**From:** [Dan Grove](#)  
**To:** [Molly McGuire](#)  
**Subject:** Existing Grade for permit 2207-019 SUB3  
**Date:** Friday, June 9, 2023 9:00:14 AM  
**Attachments:** [2207-019 Existing Grade - for SUB3.pdf](#)

I'd like to submit this document to provide enhanced information on the Existing Grade of permit 2207-019 SUB3.

Molly McGuire  
Mercer Island Community Planning and Development Department  
RE: Permit 2207-019 SUB3 / 6950 SE Maker Street  
Jun 9, 2023

Figure 11. 2022 Geotechnical data overlaid with Interpolated contour lines based on 1963 Survey, 1989 Survey, 2004 Survey, 2021 Survey, and current LIDAR.

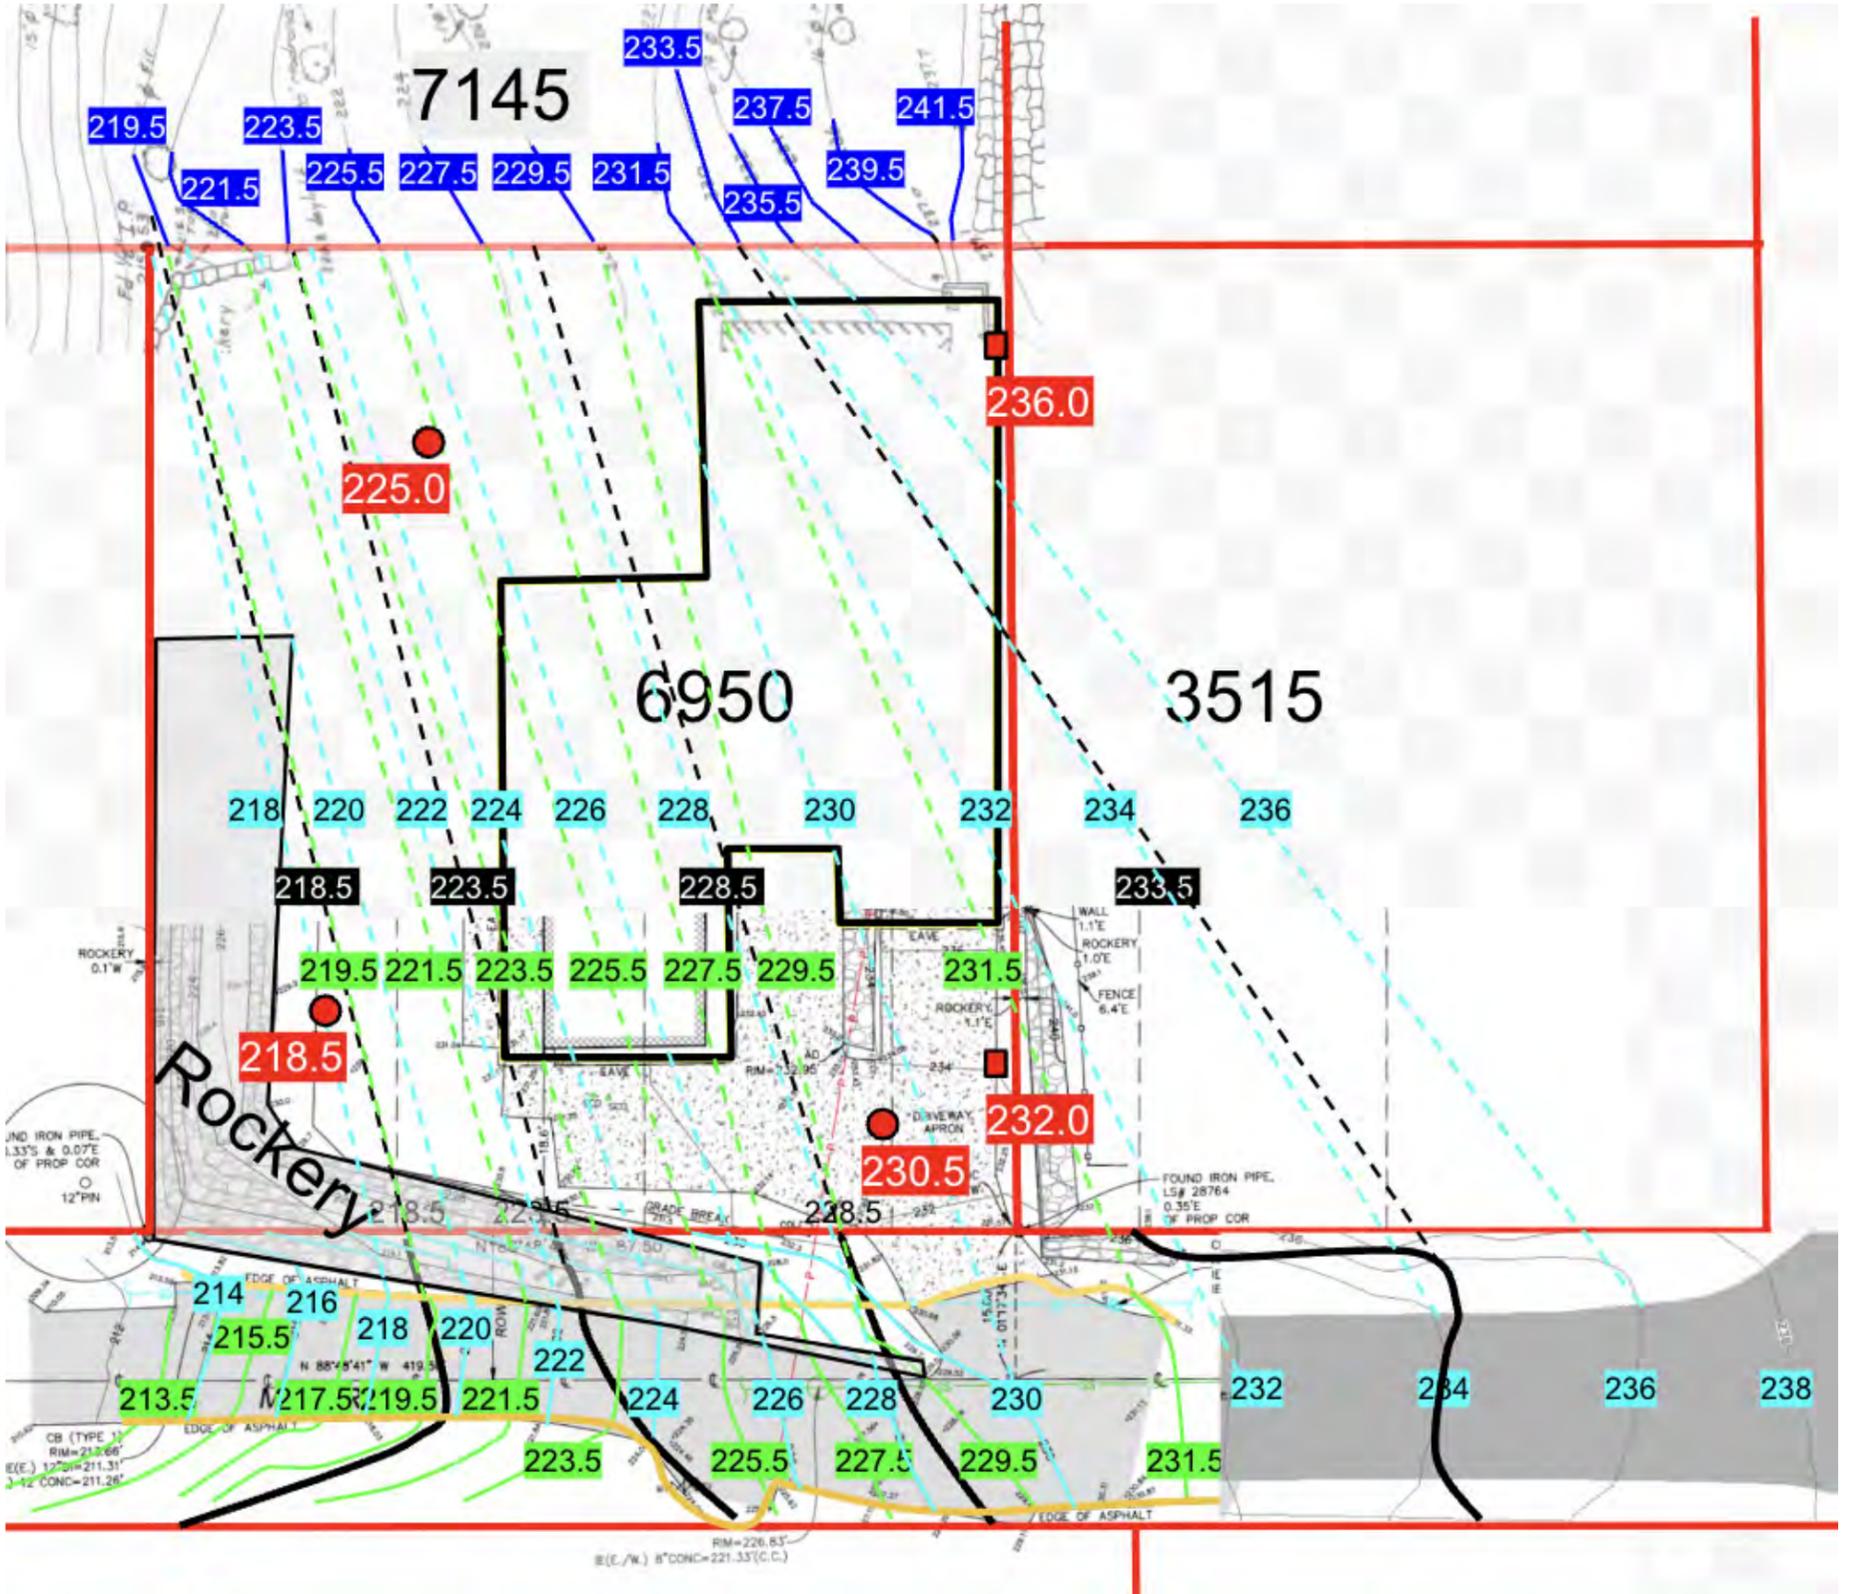
We can validate the interpolations by comparing them with data from the 2022 Geotechnical survey of the 6950 property. In Figure 11, the depth of original topsoil in the 5 bore/test holes drilled in 2022 matches the interpolated contours within a few inches.

Figure 12. Computed corner and midpoint elevations of proposed structure  
 Proposed structure shown in Magenta  
 Corner/midpoints and elevations of proposed structure shown in Dark Blue

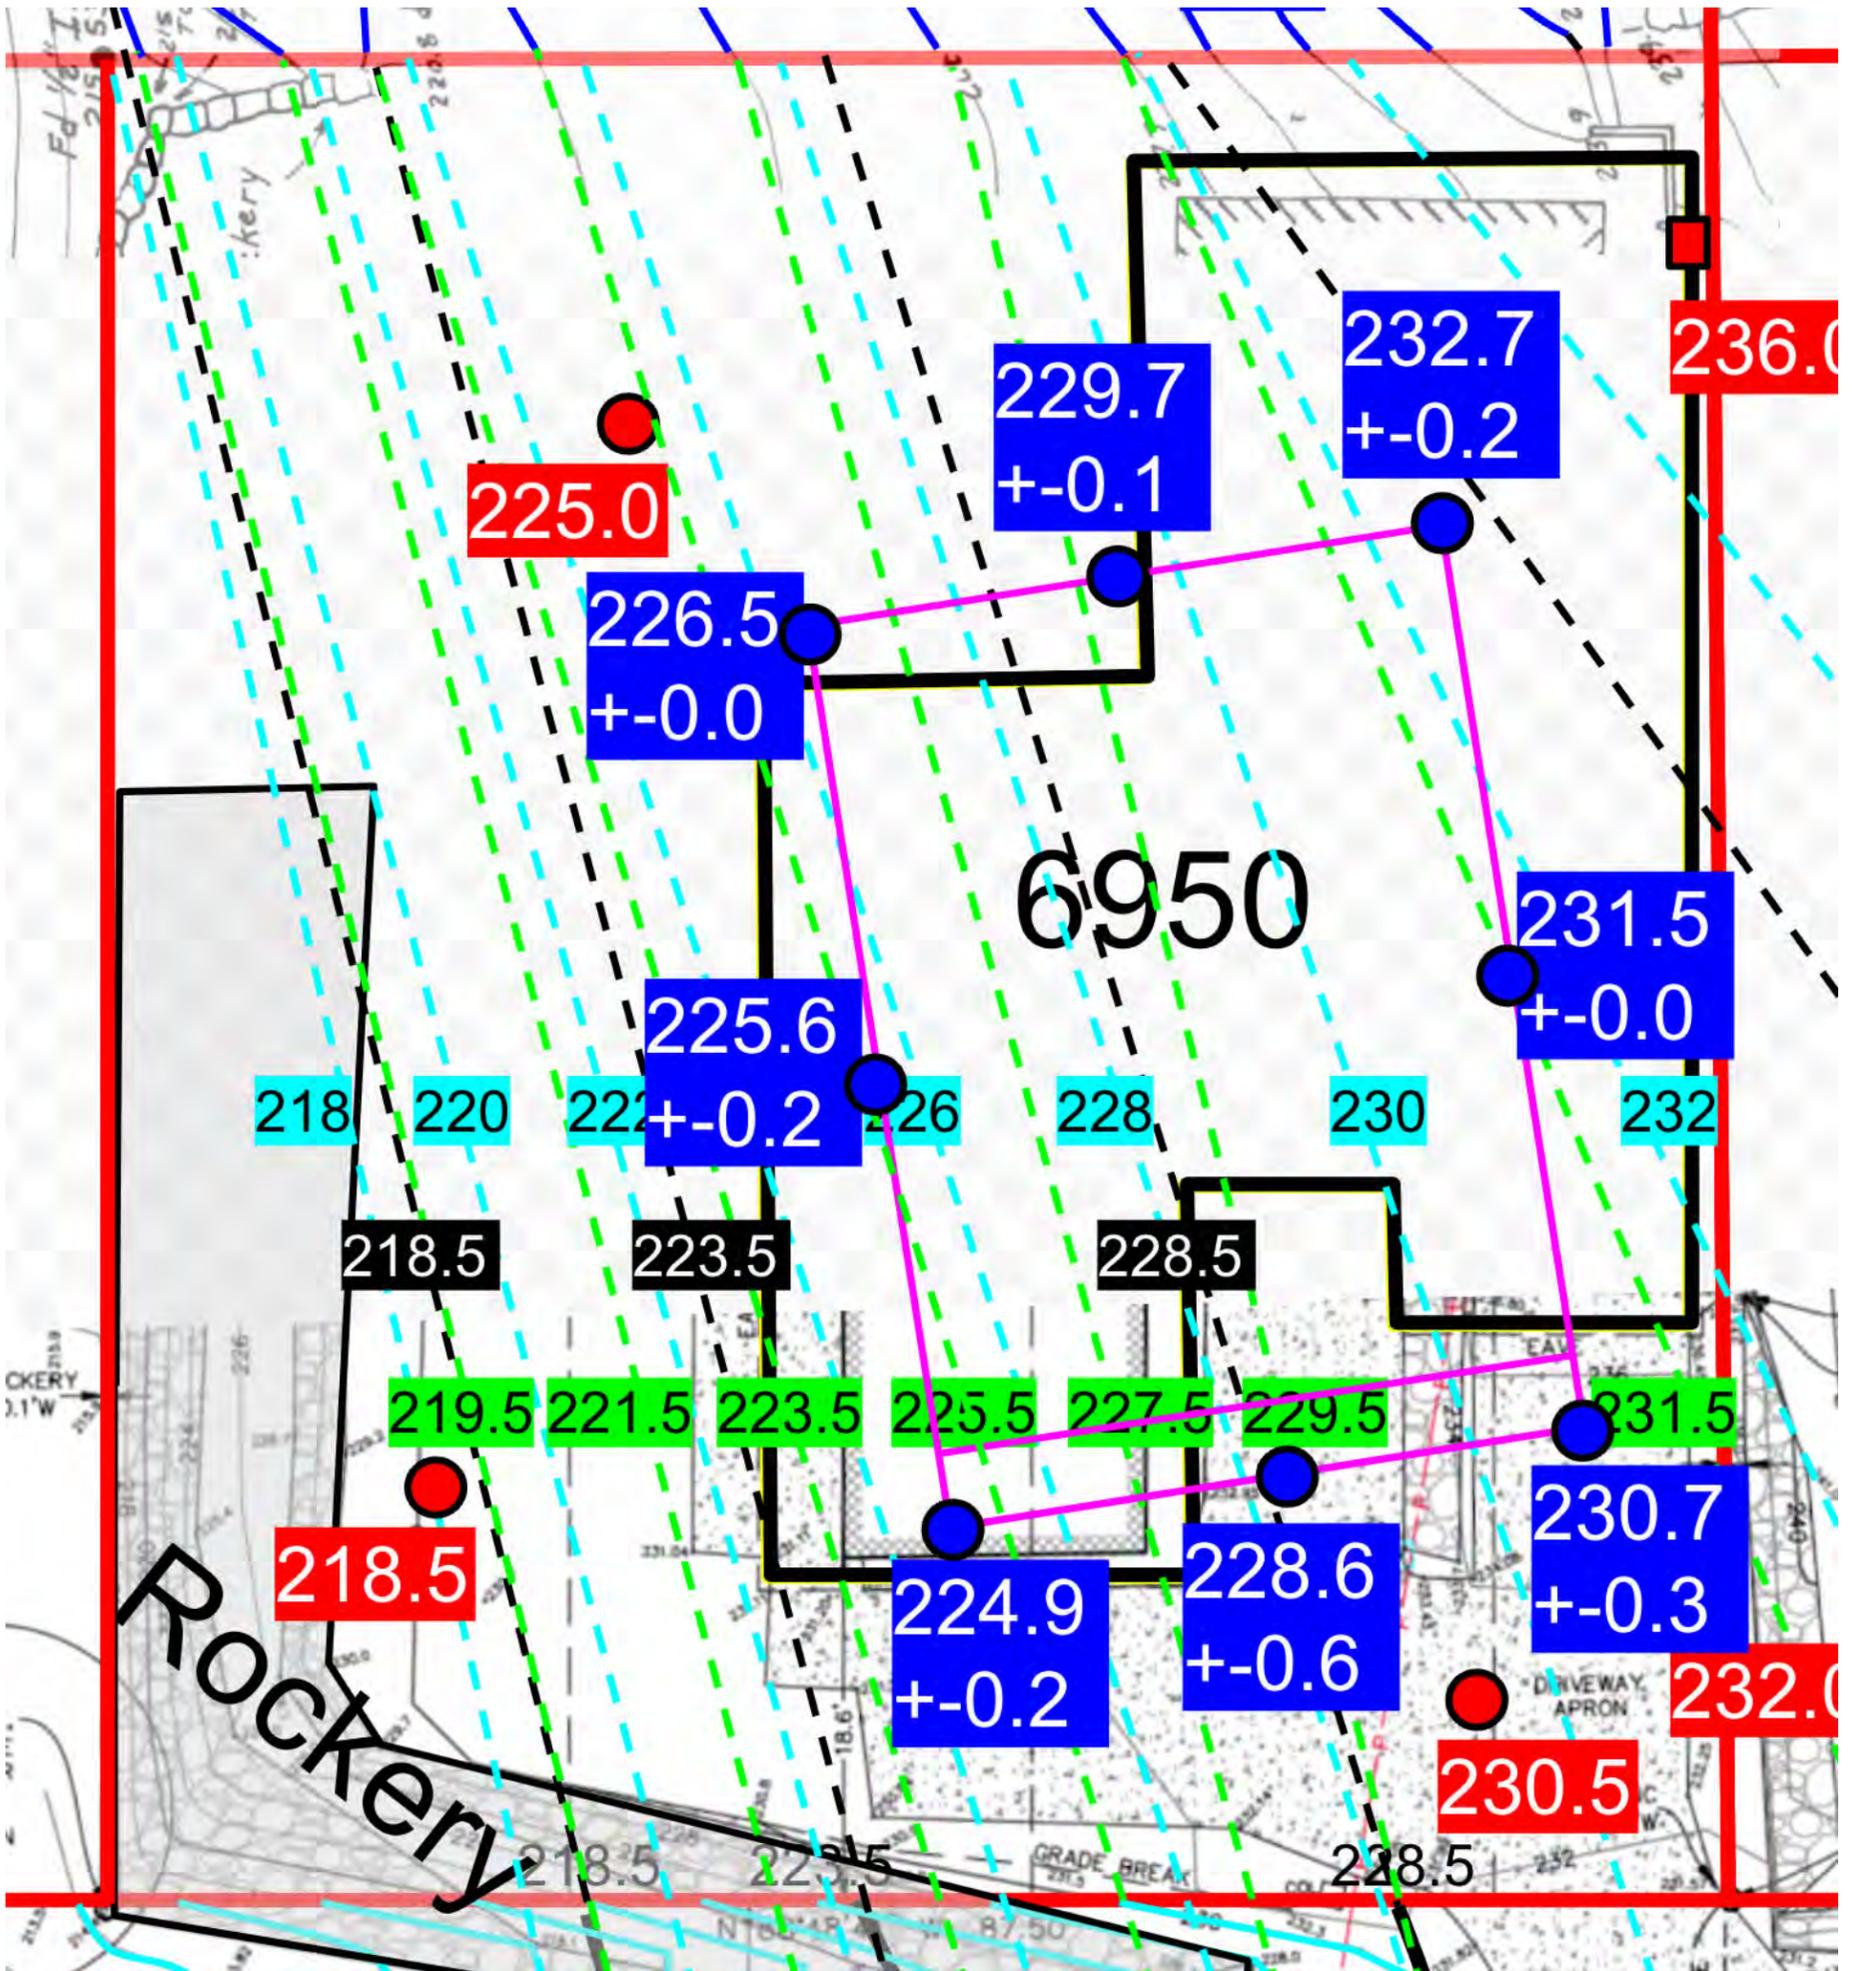
With all of this data, it's straightforward to compute the Existing Grade of the proposed structure, shown in Figure 12.

- Elevations in blue show corner and midpoint Existing Grade based on averaging the interpolated data from 3 surveys (1963, 2004, 2021)
- The +/- figures correspond to the range of elevations computed from each survey. It's clear that the 3 different survey interpolations yield essentially identical results.

The correctly-determined Existing Grade for the proposed structure can now be used to correctly calculate Basement Coverage and Average Building Elevation. For SUB3, the results of using the correct Existing Grade are as follows:

**It is worth noting that the Existing Grade of 228.4' matches the grade of the current Basement in the 2021 Survey precisely - the 2021 Basement Finished Floor elevation was surveyed at 228.7'. With a standard 4-inch slab depth, the grade basement currently sits on a 228.4' grade.**
